CITY PLANNING COMMISSION

- APPLICATION:**
- A. Negative Declaration
 - B. Special Permit to sell alcohol on-site and off-site
 - C. Special Permit to establish a 24 hour convenience market with gas dispensing facility on 0.91+ net acres in the Light Industrial-Review (M-1(S)-R) zone.
 - D. Plan Review for a 2,500 square foot convenience market, a 1,836 square foot restaurant, and a 2,160 square foot canopy over the gas island

LOCATION: 1595 Bell Avenue

P-87-262

MONUMENT SIGN IN LIEU OF POLE SIGN

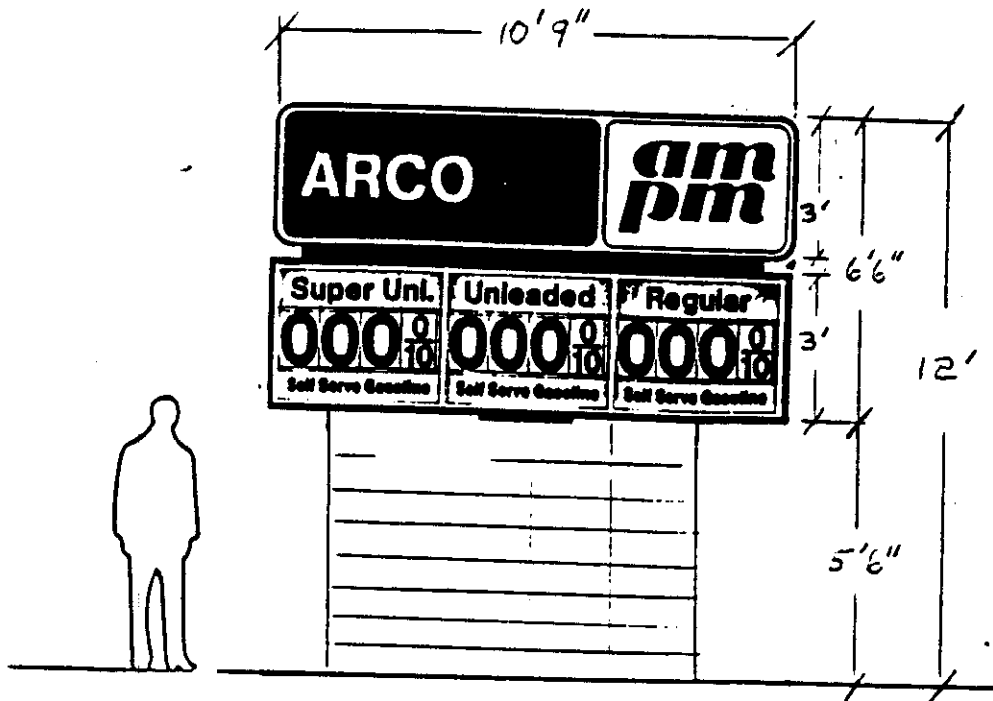
The applicant proposed internally illuminated, canned, plastic signs attached to the building and shows a pole sign. Illuminated spandrel signs are shown on the canopy. Staff supports the use of monument sign located 10 feet behind the future right-of-way of Bell Avenue and Raley Boulevard, limited to 12 feet in height and does not recommend approval of pole sign. Staff is concerned over possible duplication of price signs on the canopy and detached on the site. Staff recommends that a sign program be submitted for review and approval by the Planning Director prior to issuance of sign permits since the signs will be located on structures located within the 50 foot setback area. (Refer to Exhibits F and G for example of monument and pole sign).

STAFF RECOMMENDATION

NEW SUPER-DOUBLE ISLAND CANOPY ELEVATIONS AND NOTES

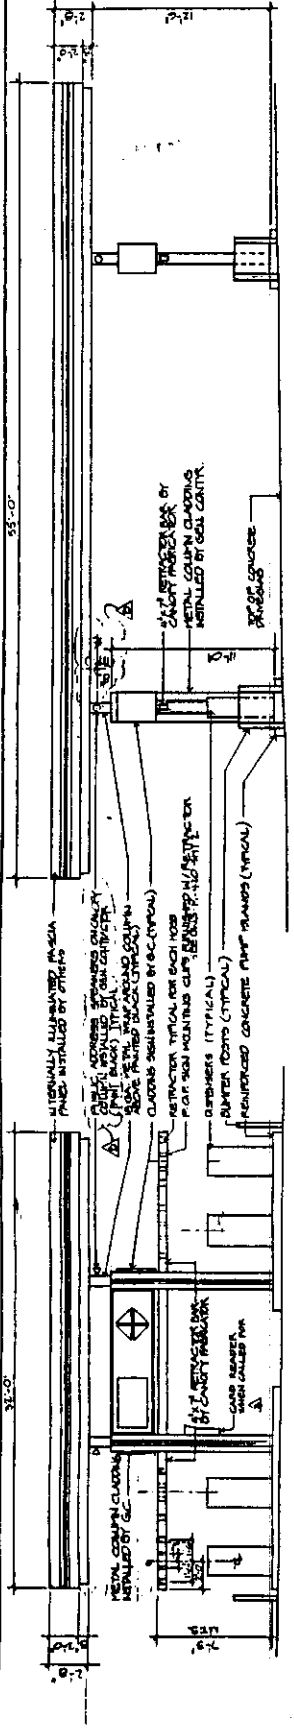
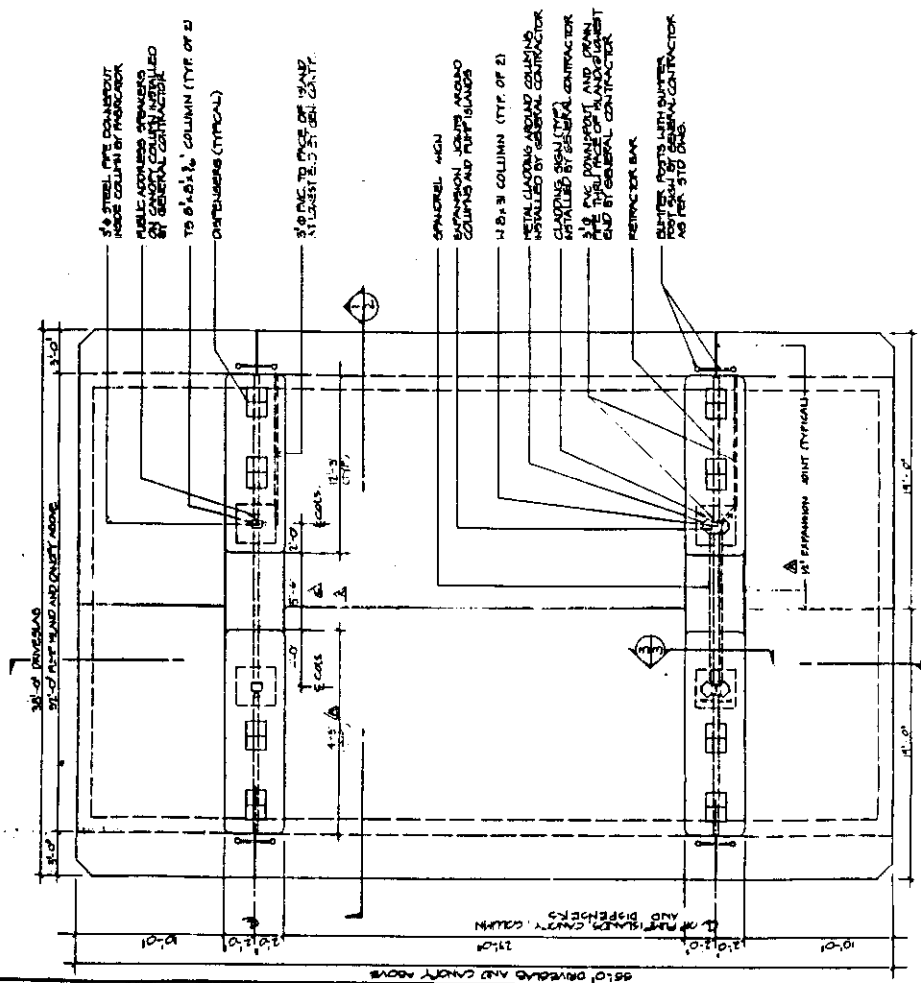
- D. Canopy: The applicant proposed to construct a 32 foot by 55 foot canopy over the islands, with an overall height of 16 feet. A total of eight pumps will be provided with four pumps per island. The canopy will have an illuminated fascia band which will outline the canopy which is painted the Arco blue, orange and white bands. The canopy color is considered part of the signage so that direct illumination constitutes a violation of the City Sign Ordinance. In order to comply with the Sign Ordinance, the internally illuminated fascia should be modified to delete the lighting fixtures. Sufficient lighting under the canopy will provide on-site illumination. Eight two feet by two feet florescent light cabinets are proposed under the canopy.

The canopy also shows two external loudspeakers. The volume of the loudspeaker system shall be adjusted so to not be audible off-site. The purpose of the speakers is to provide directions to users of the pumps. No music or constant usage is planned. Staff does not recommend constant noise from the speakers due to the proximity of the site to residential land uses.

14. No perimeter fascia or soffit lighting which accents either the convenience market building or canopy structure is allowed. Revised elevation drawings shall delete the florescent light fixtures in the soffit and fascia panels for the canopy and mini-market.
